NOTICE OF DECISION REGARDING SUBDIVISION CONSENT

Consent No.: 63-05-075
Applicant: Eastgate Developments Ltd.
Location of proposal: Pukehangi Road.
Legal Description: Lots 2 & 3 DP 343069, Lot 2 DPS 40792 and Pt Kaitao Rotohokahoka 2M2B Block.
Proposal: Stage A - Subdivision of the Rural B1 portion of land into 35 Lots in accordance with the Approved Development Plan (Appendix G2), leaving the balance Rural A lot.

PROJECT/LOCATION
PUKEHANGI ROAD
ROTORUA
SCHEME PLAN

DRAWN: GD	DESIGNED: LSM
CHECKED: LSM	SURVEYED BY: .
LOCAL AUTHORITY REF:	
SCALE: 1:2500	ORIGINAL DWG. SIZE A2
DRAWING No. 173975-R-P-D003	SHEET No. 01
	ISSUE E

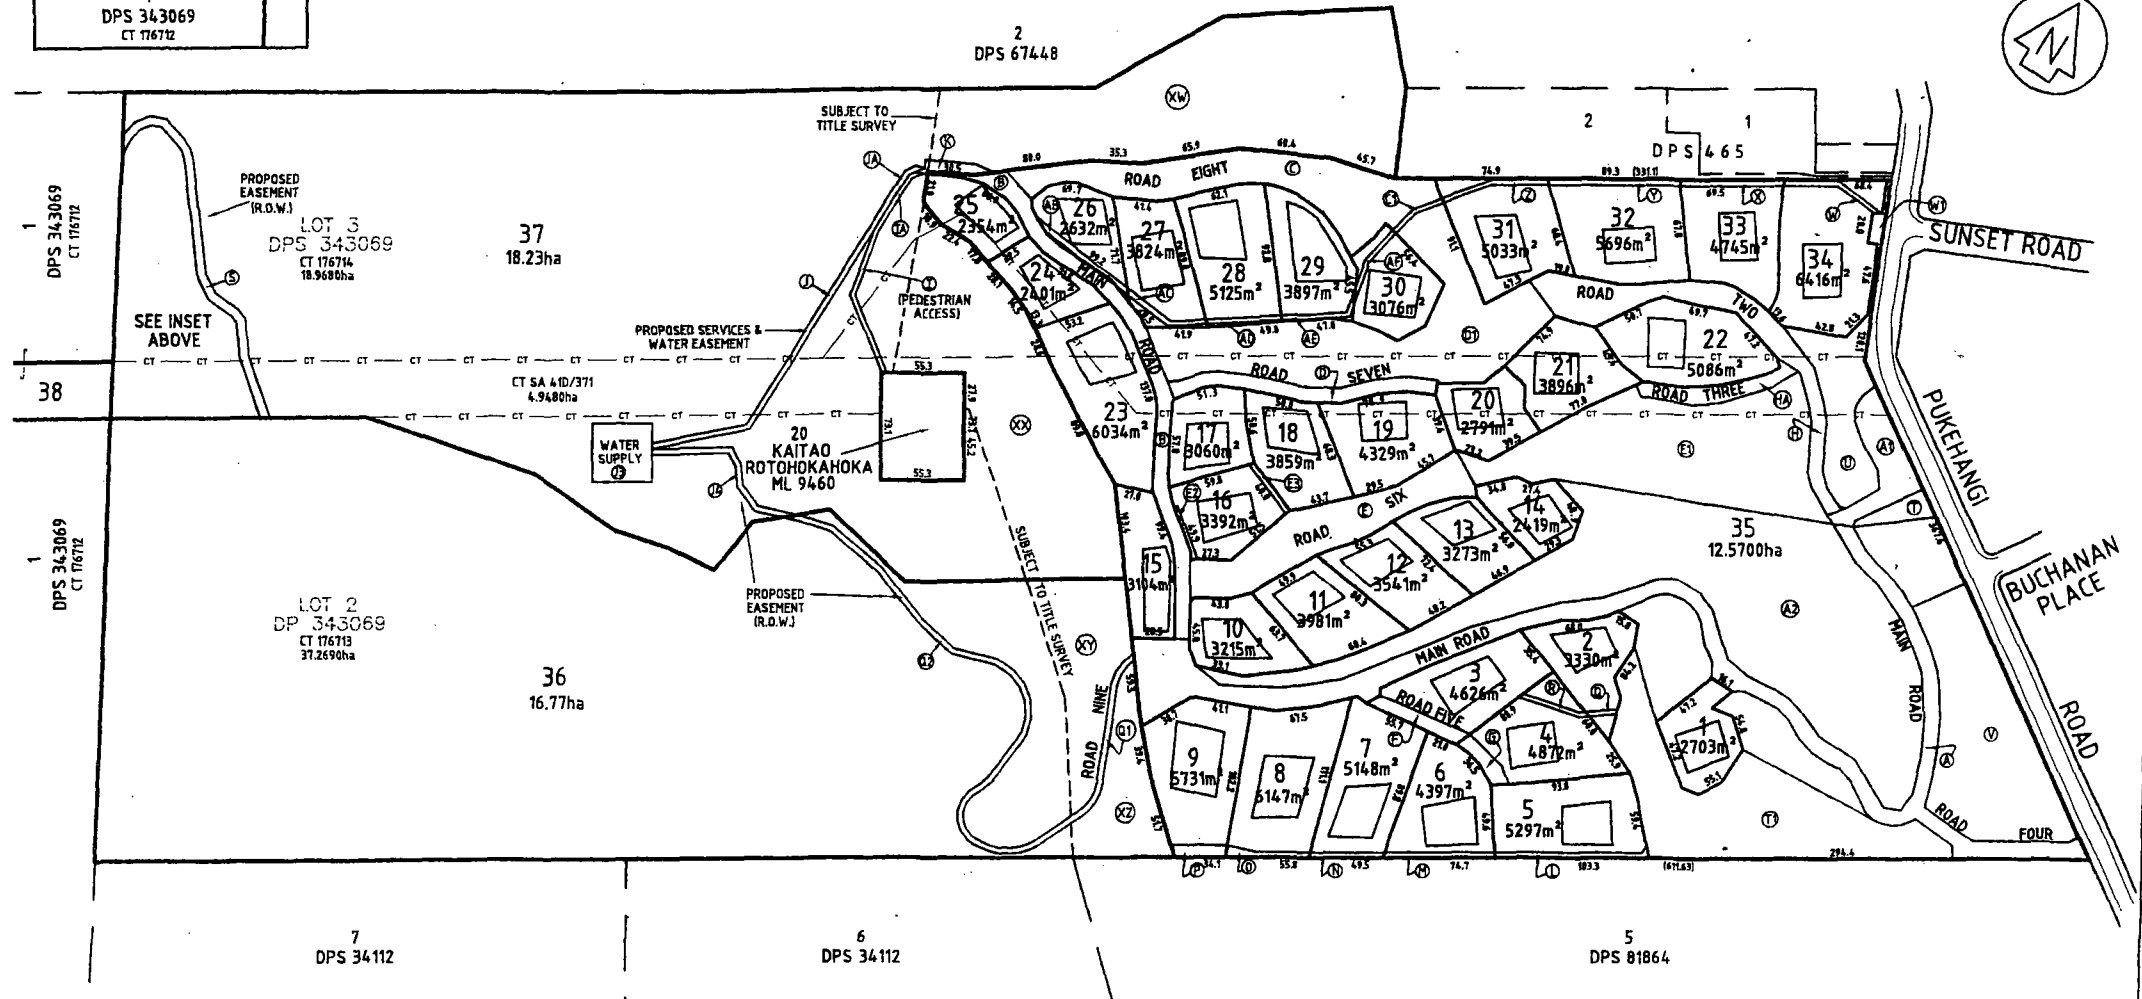
1. That the Land Transfer Plan for Lots 1-35 shall be prepared in accordance with the preliminary plan of subdivision prepared by MTEC Consultants, numbered 173975-R-P-D003 Sheet 01, Issue E and dated 20/07/05 that also shows designated building platforms. Lots 36-38 shall be shown as one lot.

34. That all buildings (houses and any accessory buildings) shall be sited within the identified building platforms for each lot as shown on the approved preliminary plan of subdivision 173975-R-P-D003 dated 20 July 2005 and that this be shown as designated house sites on the land transfer plan.

AMALGAMATION CONDITION
THAT LOT 38 HEREON BE TRANSFERRED TO THE OWNER OF LOT 1 DP 343069 & LOT 2 DP 5 67448 CT 176712 AND THAT ONE CERTIFICATE OF TITLE BE ISSUED TO INCLUDE BOTH PARCELS.
